Proposed Moor Street / Carlton Street Cyclist Improvements

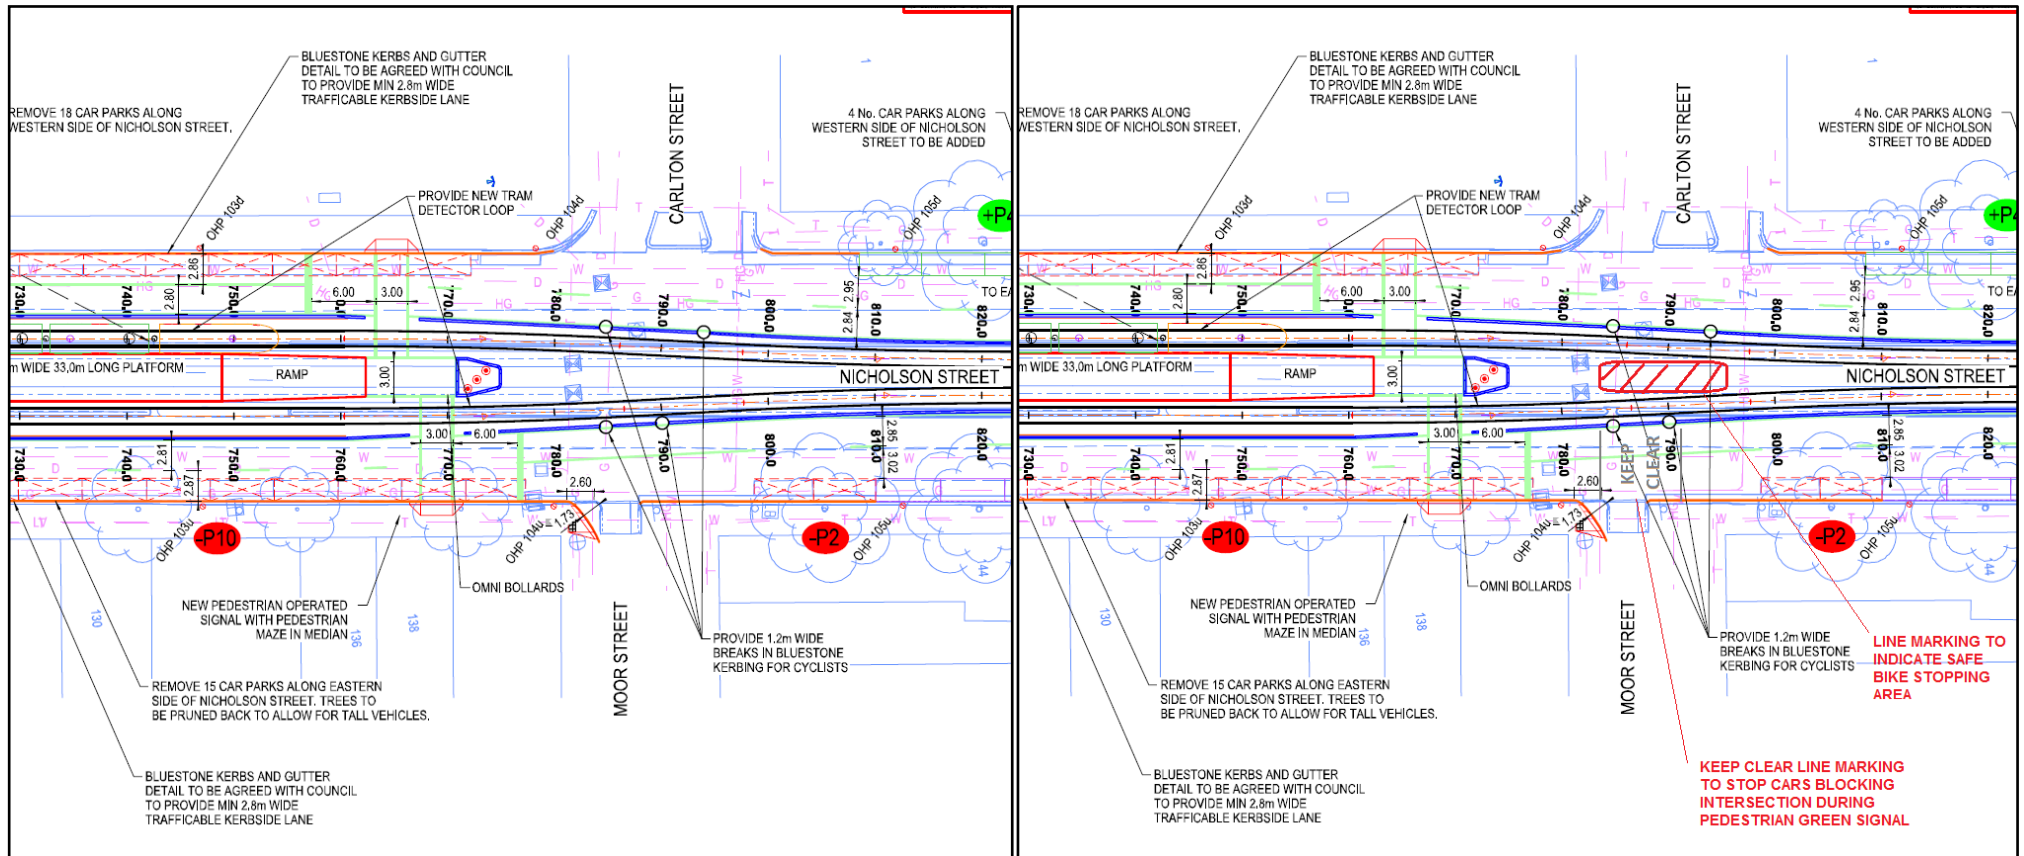
Breaks have been included in the splitter islands, allowing cyclist movements through the intersection; however when southbound cars are queued behind the pedestrian crossing they are likely to block the intersection, inhibiting cyclist movements while vehicle traffic has stopped.

To prevent southbound vehicles from blocking the intersection, it is now proposed to add 'Keep Clear' linemarking at the intersection. Additionally, line marking between the tram tracks is proposed to indicate where cyclists may wait if they need to stage their crossing.

No keep clear linemarking is required on the northbound side of Nicholson Street, as would rarely be queueing this far south of the Johnston Street traffic lights.
